From: Erica Klingfus <eklingfus@msa-ps.com>
Sent: Wednesday, February 12, 2020 4:01 PM
To: Flietner, Barbara J - DNR
Subject: RE: Webster VOC 02-07-000337
Attachments: D.2.b Detailed Site Map (Murray Apt).pdf; D.2.b Detailed Site Map (Tap Bar).pdf; 2407_001.pdf

From: Flietner, Barbara J - DNR <Barbara.Flietner@wisconsin.gov>
Sent: Friday, February 7, 2020 1:45 PM
To: Erica Klingfus <eklingfus@msa-ps.com>
Subject: RE: Webster VOC 02-07-000337

**Soil Boring/
 Monitoring Well Configuration
 Rob's Amoco Station Site
 Webster, Wisconsin**

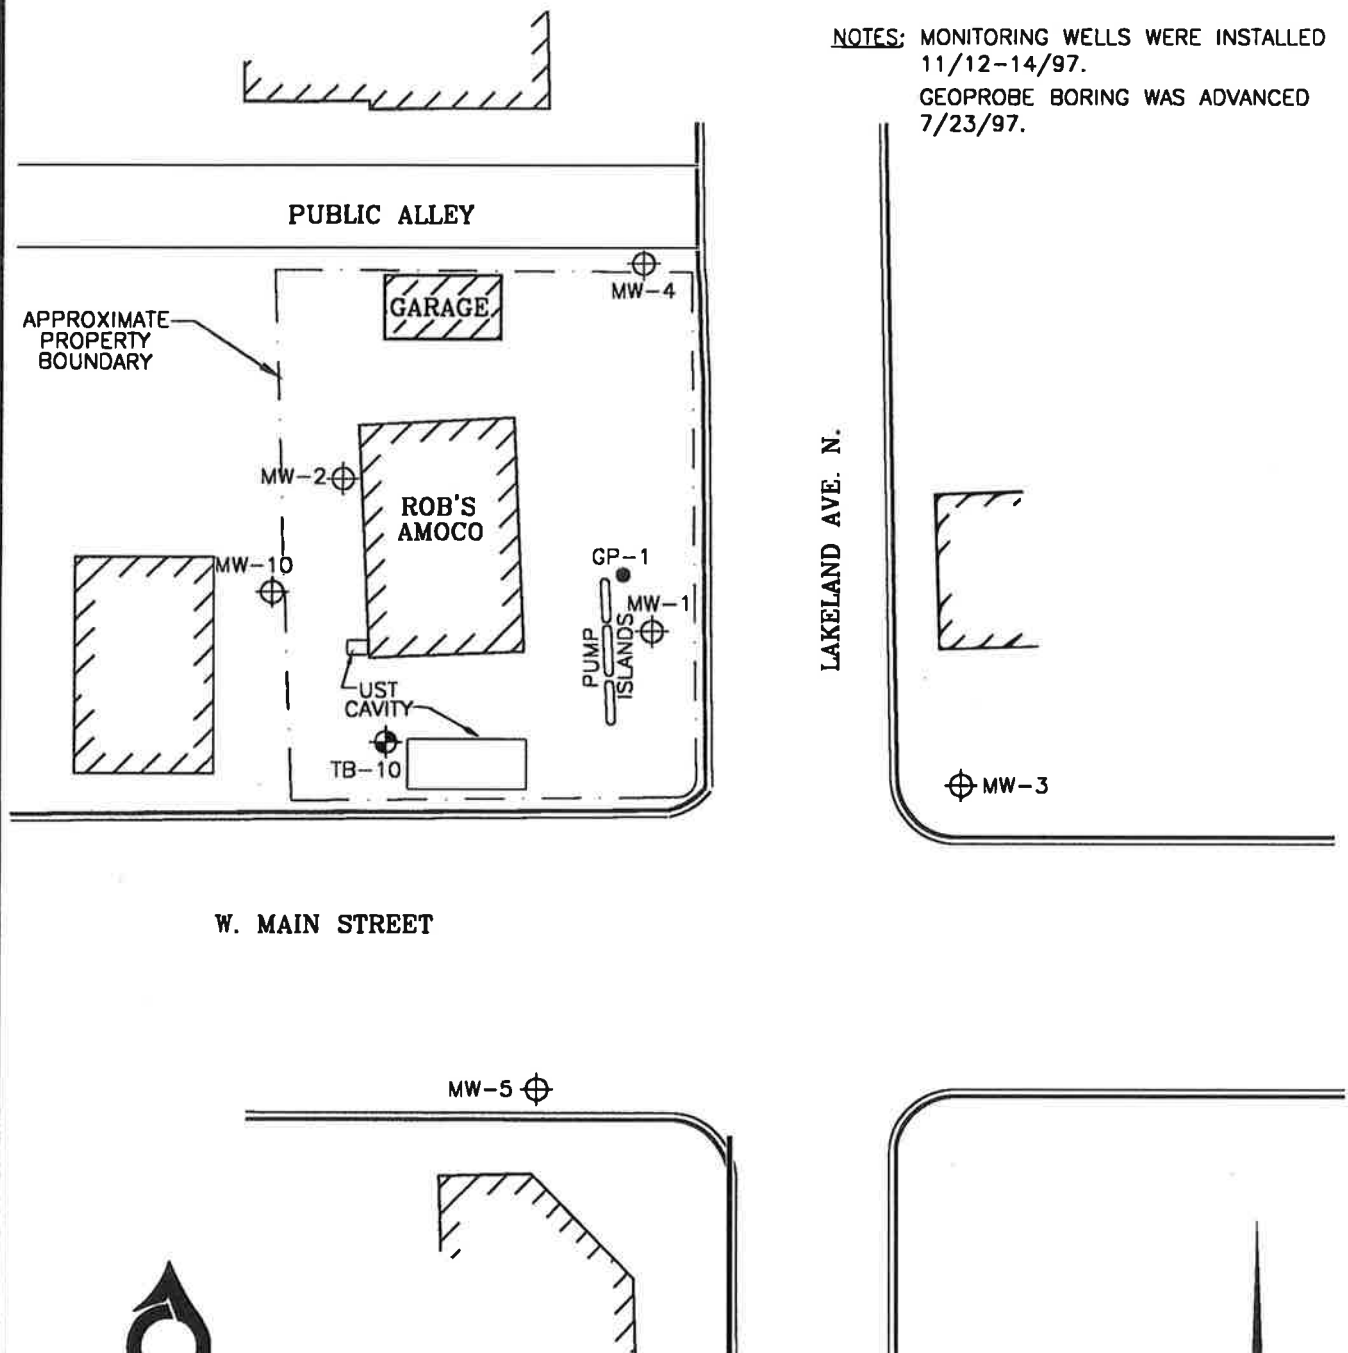
Confirm location of GP12 and neighboring property petroleum plume (map of plume?).

There were no groundwater samples collected between the tank basin (TB-10 was only advanced to 15 feet bgs to collect soil samples) and GP-12 to the west. Petroleum groundwater contamination was encountered monitoring well MW-10, but not above PALs. I'm also not sure how deep this groundwater sample was collected, as the boring information only indicates it was advanced to 15 feet bgs (groundwater we have encountered has been deeper than 30 feet). We aren't really able to draw a plume map connecting GP-12 to Rob's Amoco as there were no samples collected in this area of the Rob's Amoco site. I've attached the map from the Rob's Amoco closure request in the BRRTS database.

DETAILED SITE MAP
TAP BAR
7408 MAIN ST
WEBSTER, WISCONSIN

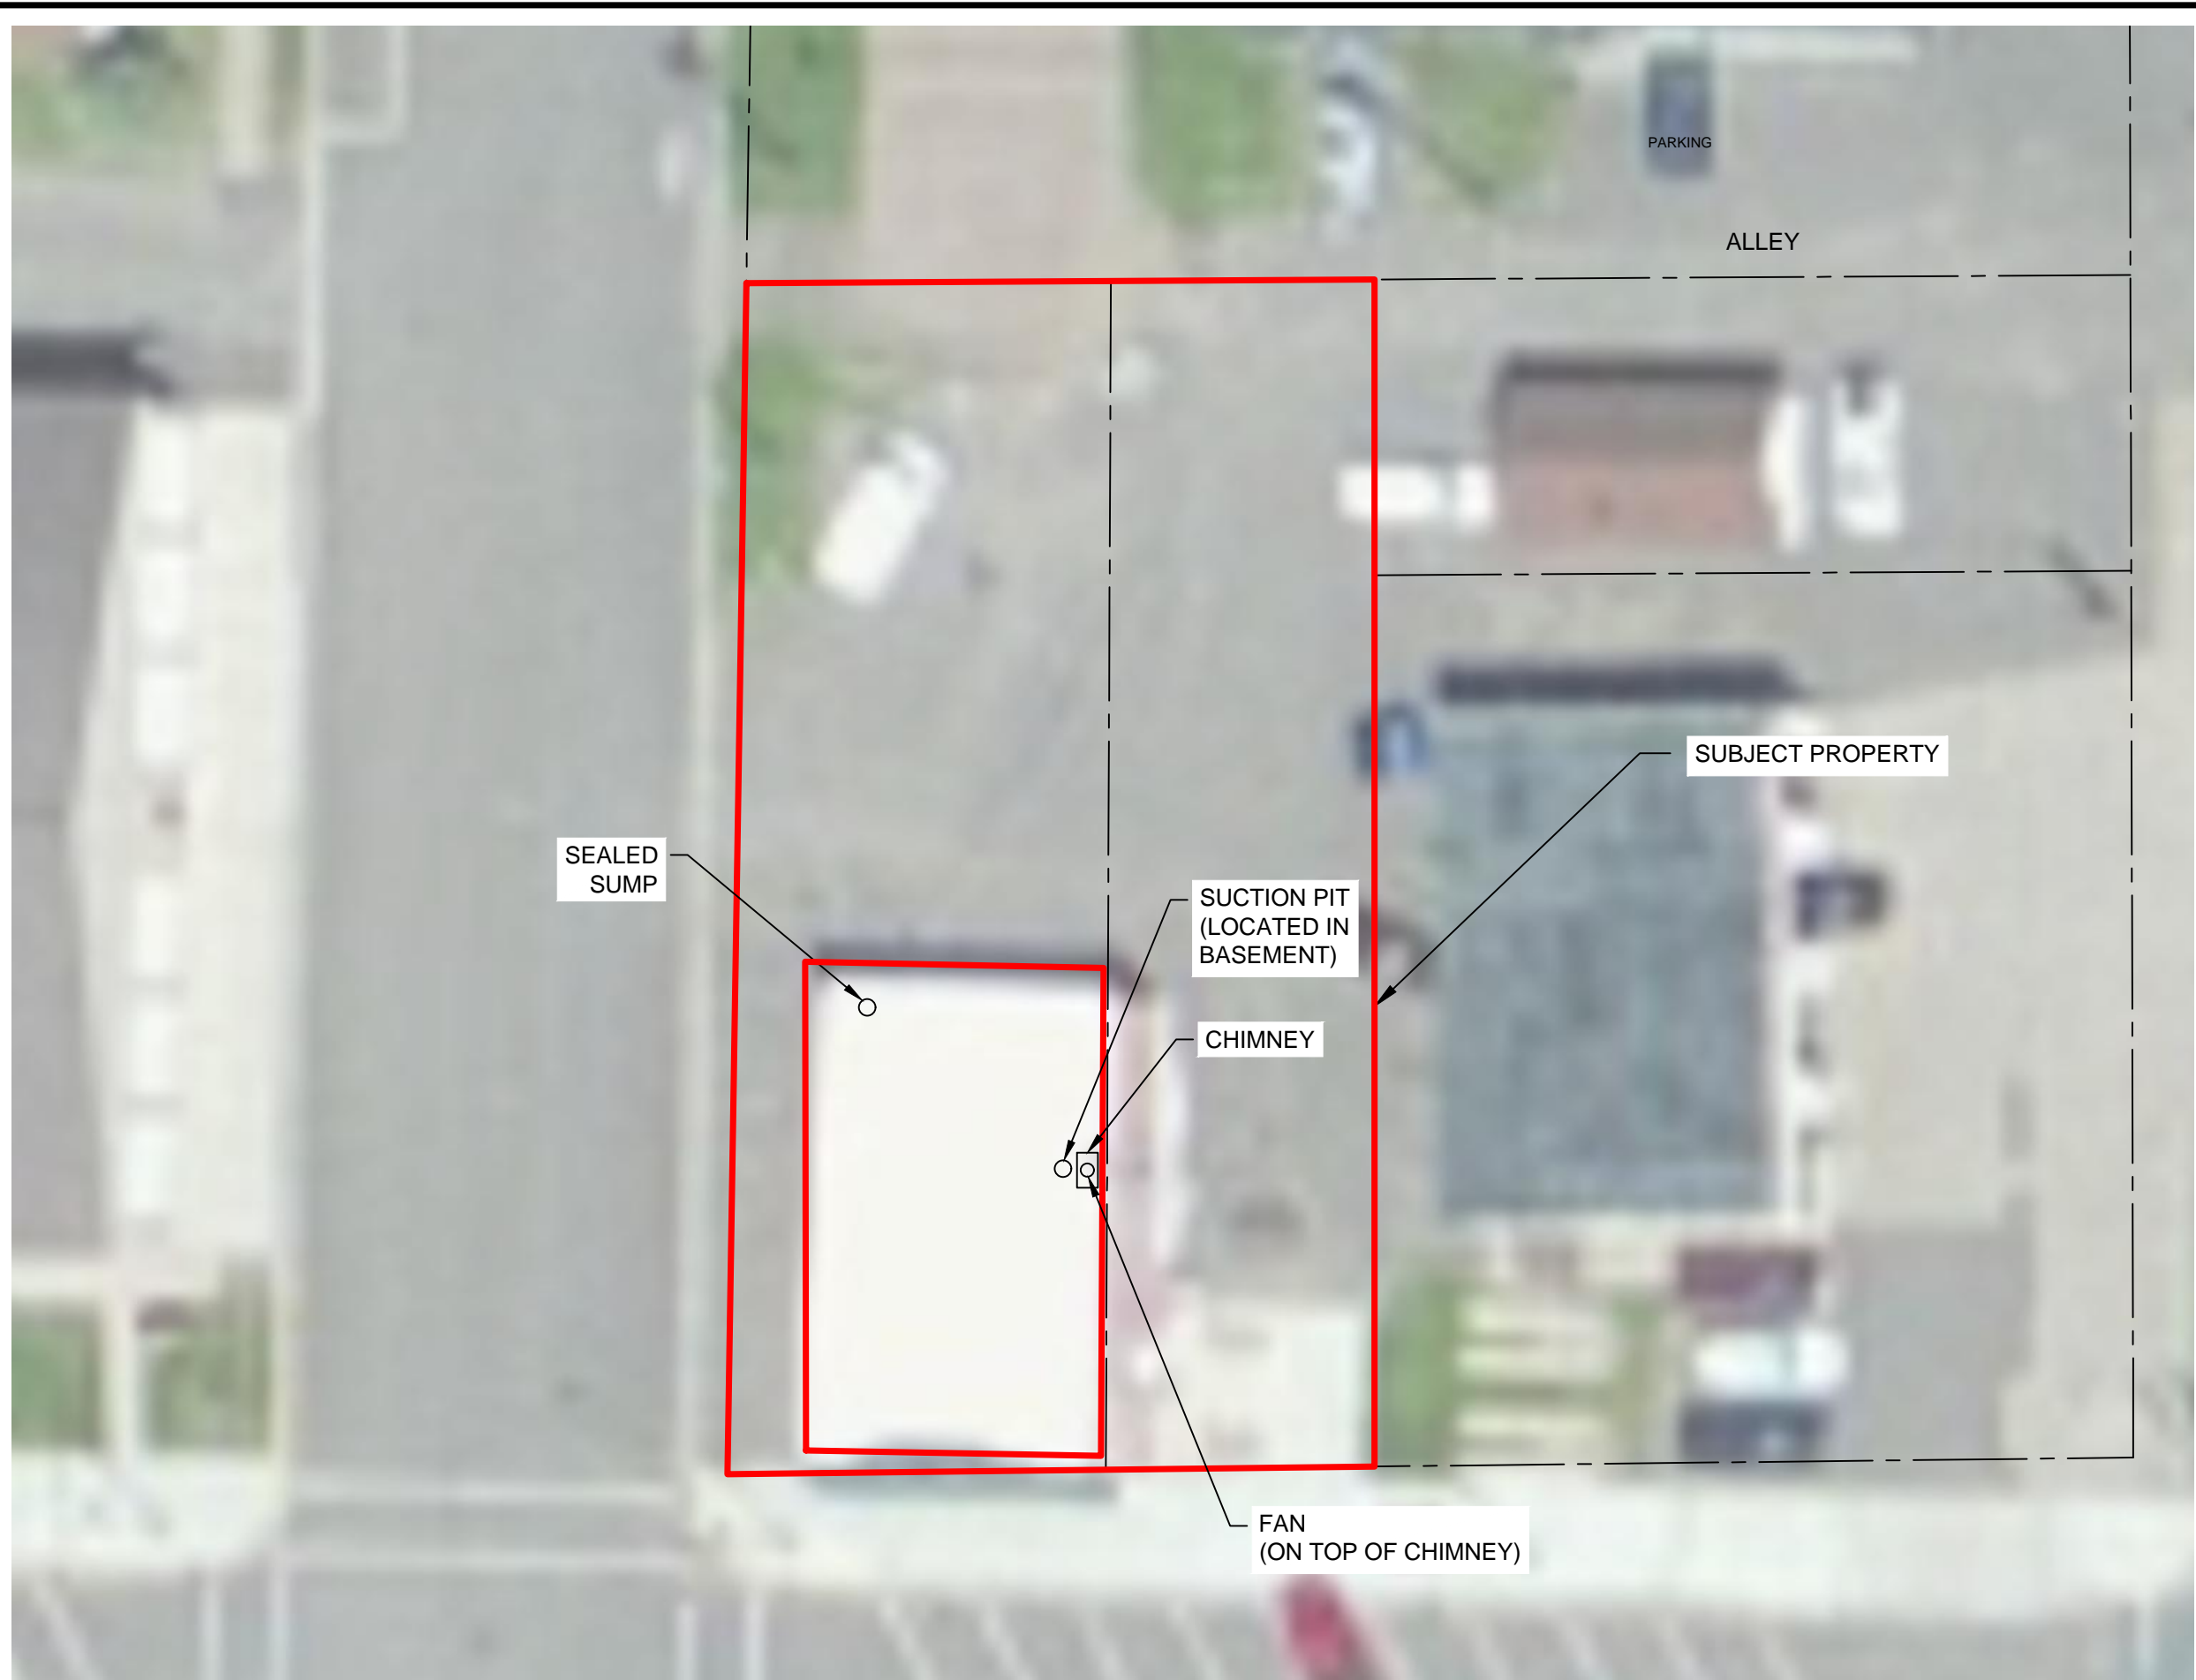
As-builts for the vapor mitigation system were suggested to be provided, as well as the status of the vapor points, so additional sampling could be conducted if viable or requested.

I've attached maps for the vapor mitigation systems installed at the Tap Bar and the Murray Apartment. The maps (along with additional information regarding the systems) were included with the closure request submitted in July 2018. All sub-slab vapor points installed by MSA are still in place.
